Re: Site Plan and Lot Line Revision for Webb Properties, Inc., Town of Newburgh
Planning Board **Project Number 2014-10.**

NARRATIVE

1. The following revisions were made to the plans for the new dealership building since the August 7th meeting of the planning board.

Subdivision Plan - Lot Consolidation
for Lands of
Webb Properties, Inc.

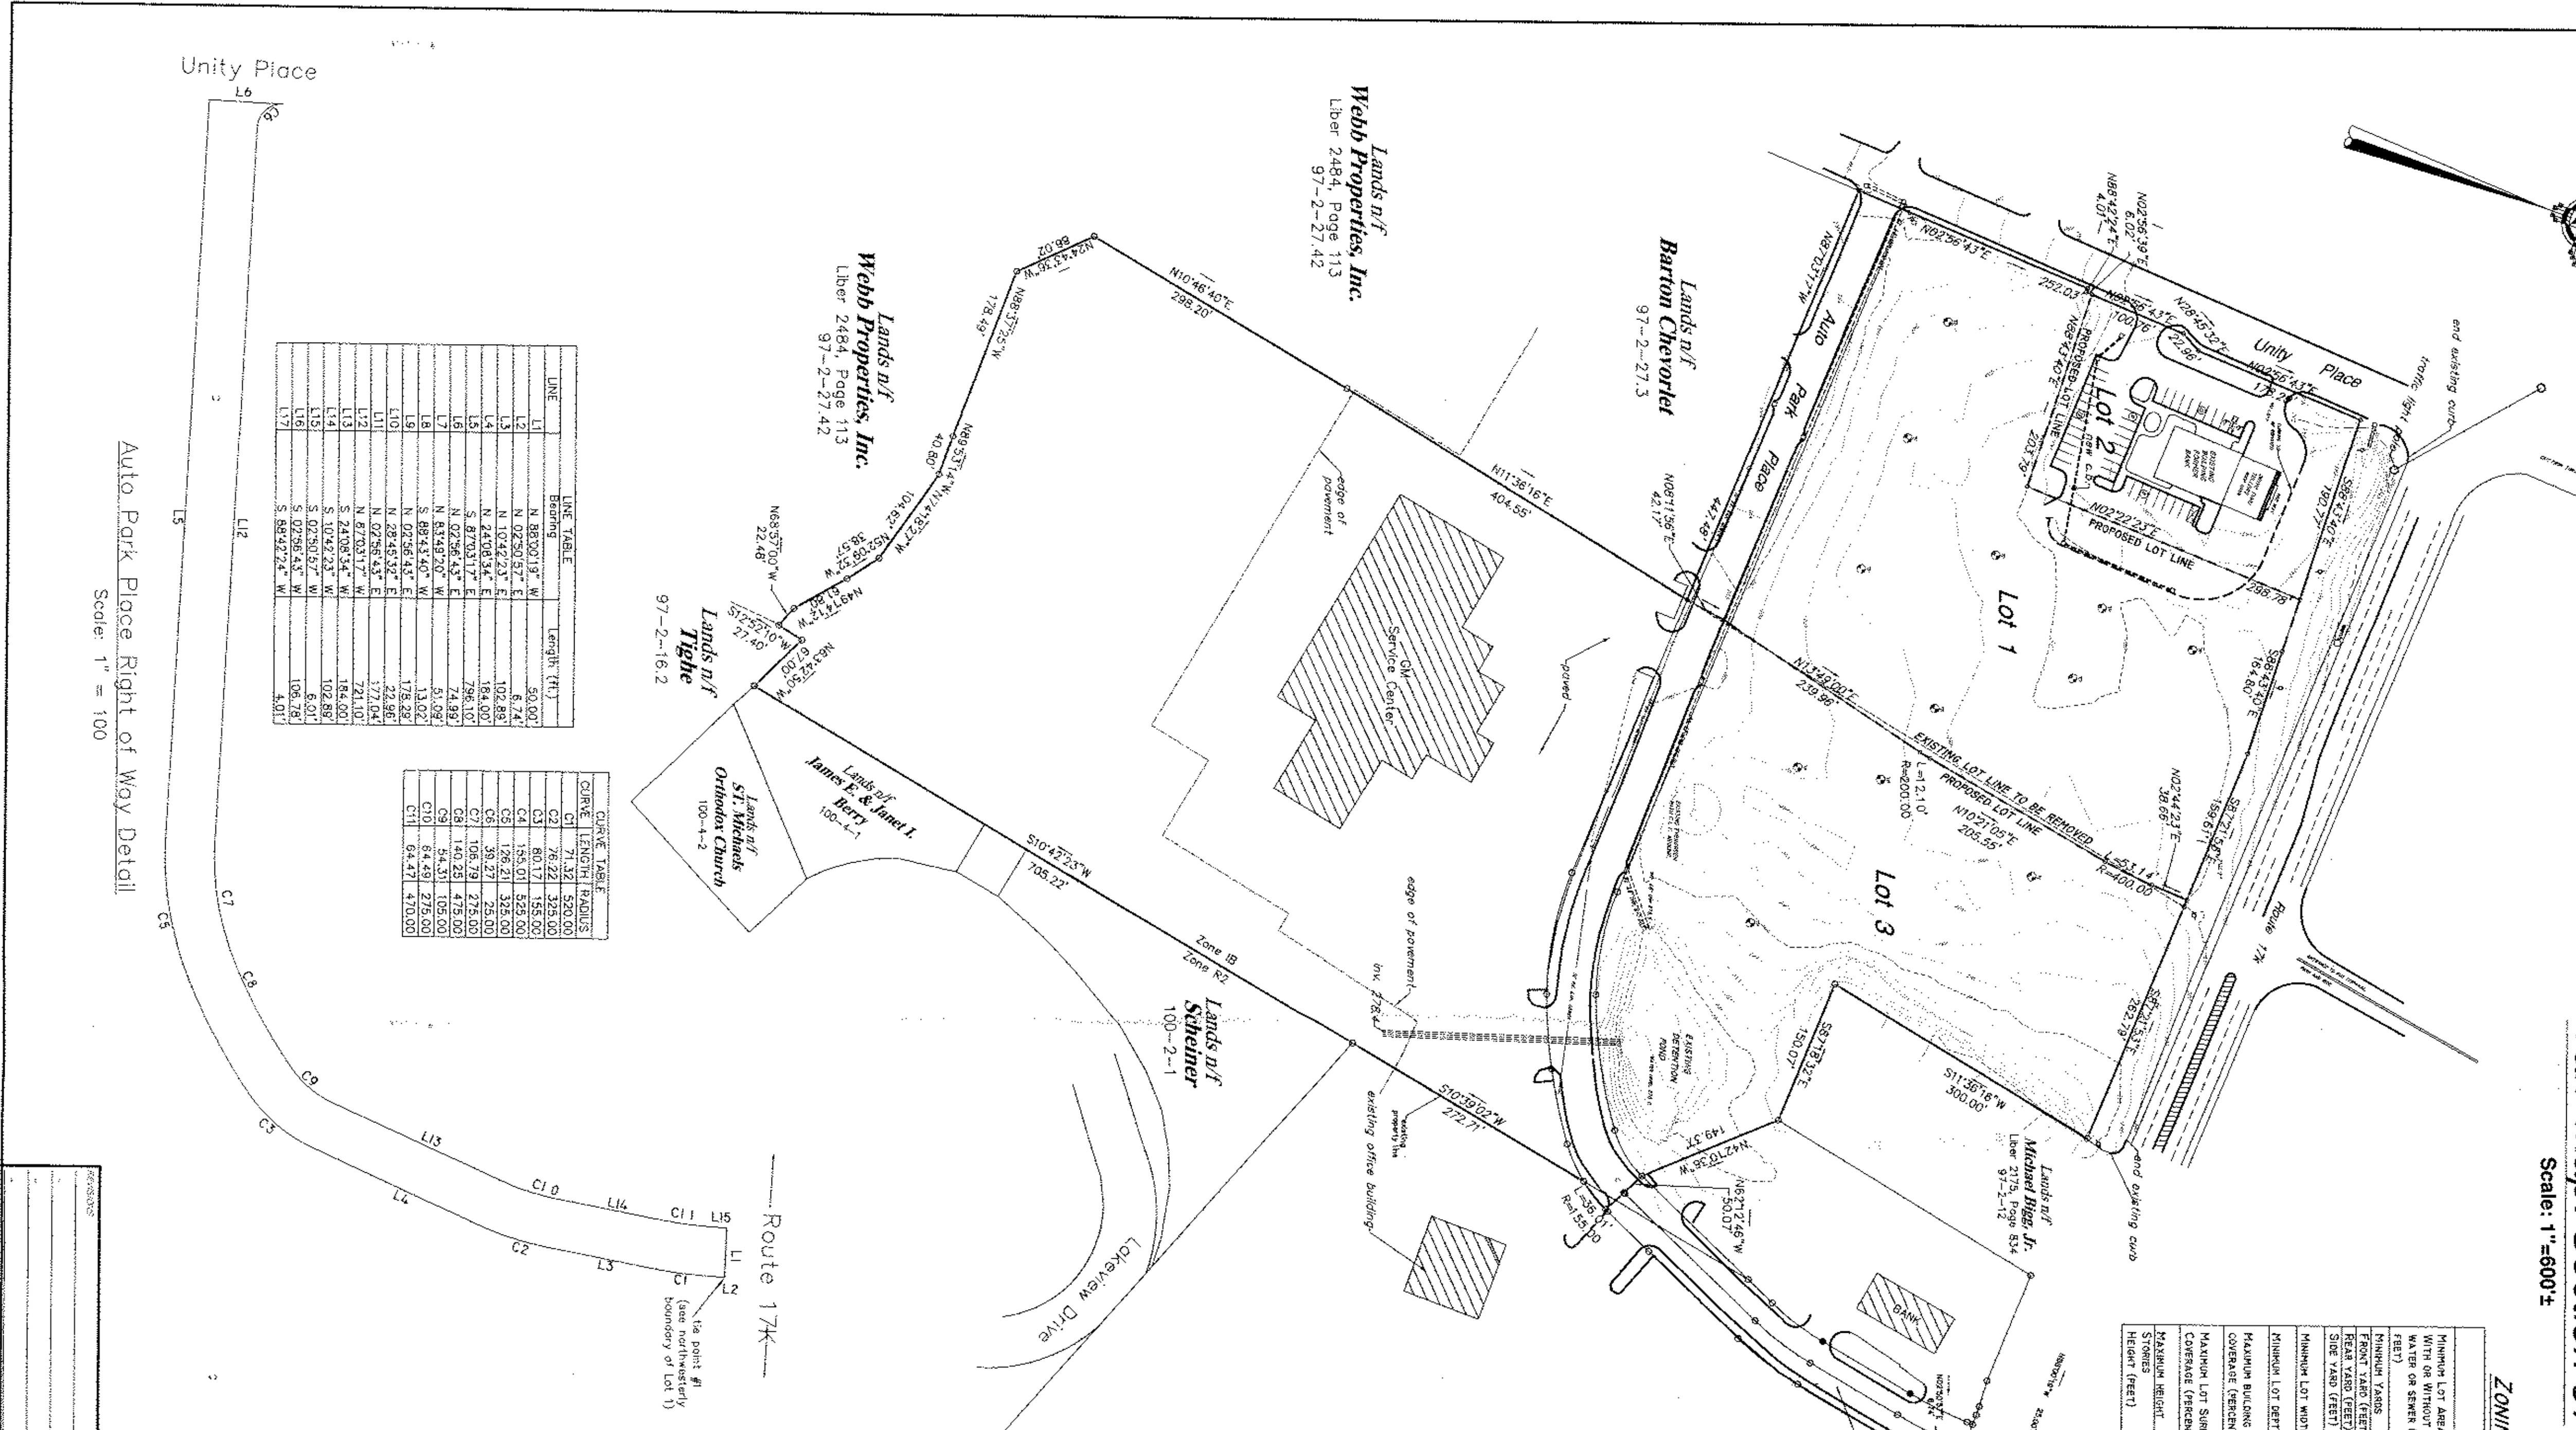
a. This project now has part of the drawing set a separate map of a subdivision involving an additional tax parcel - namely 97-2-13.22, and is shown as Lot 3 on this new map (MH&E comment #6, and #7 July 30, 2014). Tax lot 97-2-13.22 currently has the GM service center thereon. Easements notes are shown on sheet 2 of 7.

**Landscaping, Signage,
 Lot Coverage Calculations
 Site Plan
 for
 Webb Properties, Inc.**

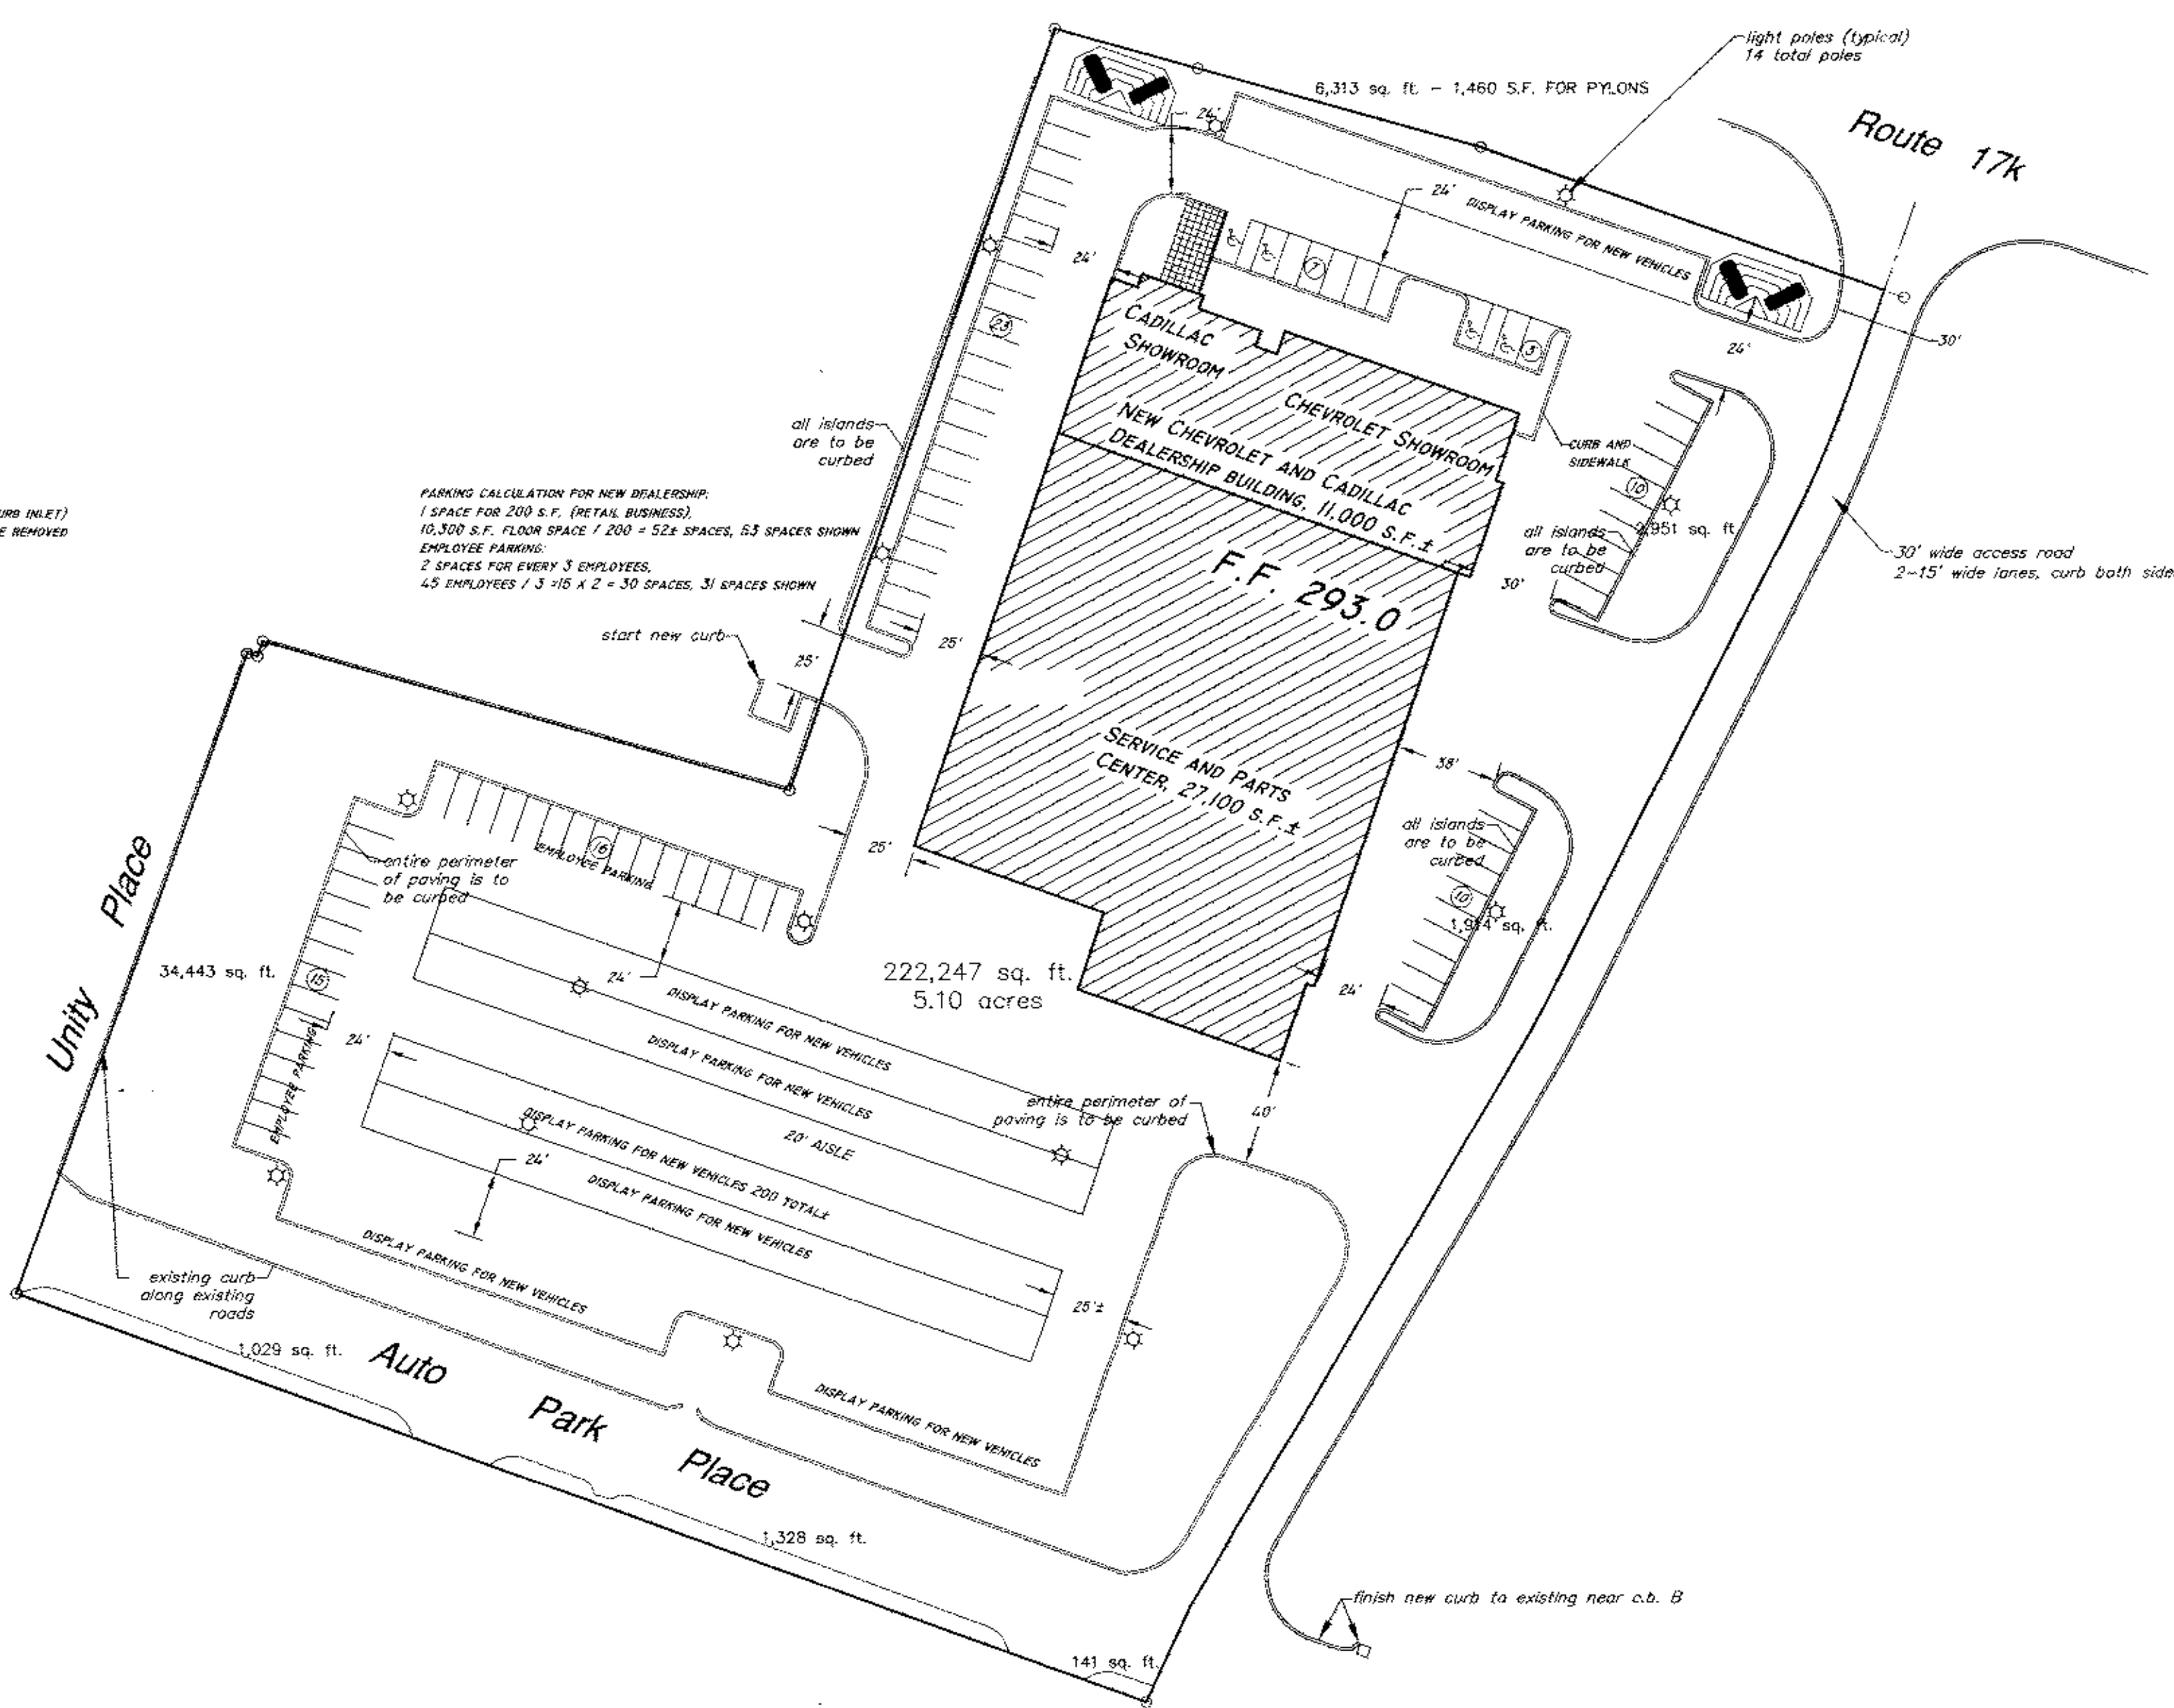
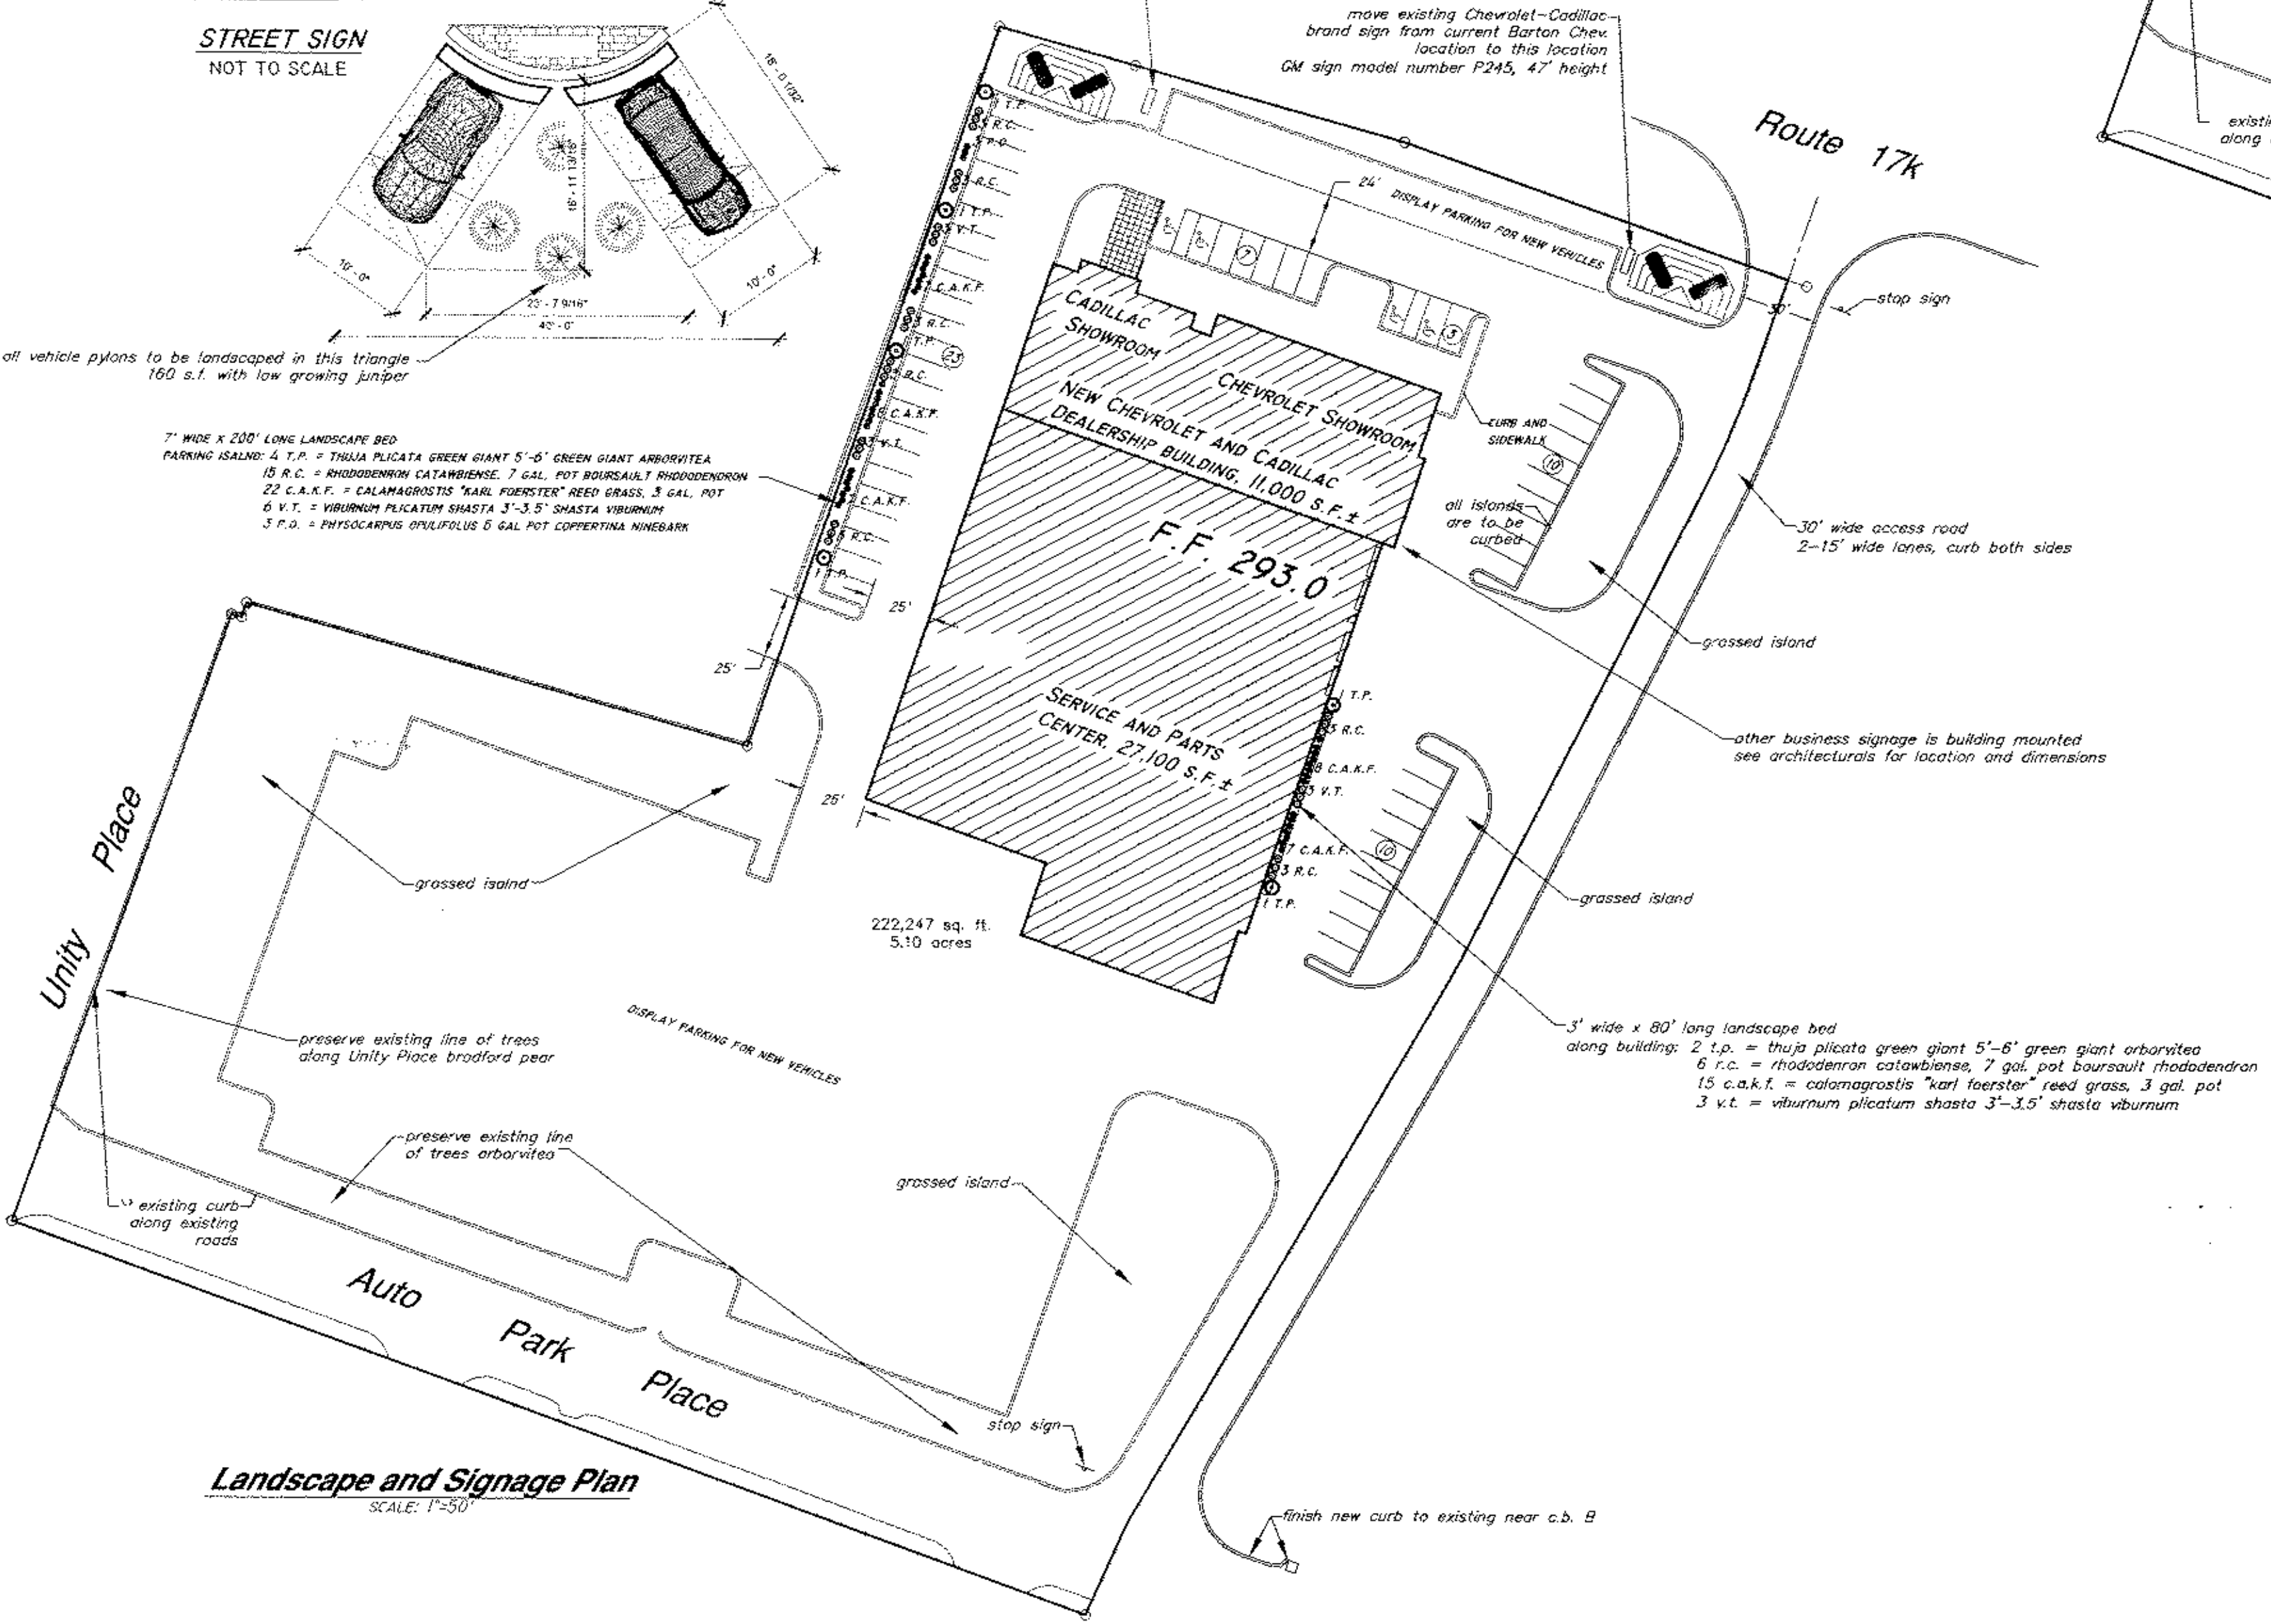
c. The improvements on the bank parcel, bulk table, parking calcs, and site details are shown (MH&E comment #3 July 30, 2014).

PARKING CALCULATION FOR FORMER BANK PARCEL: AT 1 SPACE FOR 150 S.F. (RETAIL BUSINESS)
 4,200 S.F. BUILDING / 150 S.F. PER SPACE = 28 SPACES
 (SEE SITE PLAN FOR LAYOUT)

PROPOSED LOT COVERAGE CALCULATION
 SCALE: 1"=50'
PROPOSED LOT OPEN SPACE 15,179 S.F. OR 26%± OF TOTAL LOT AREA
PROPOSED LOT COVERAGE = 74%, MAXIMUM LOT COVERAGE = 80%
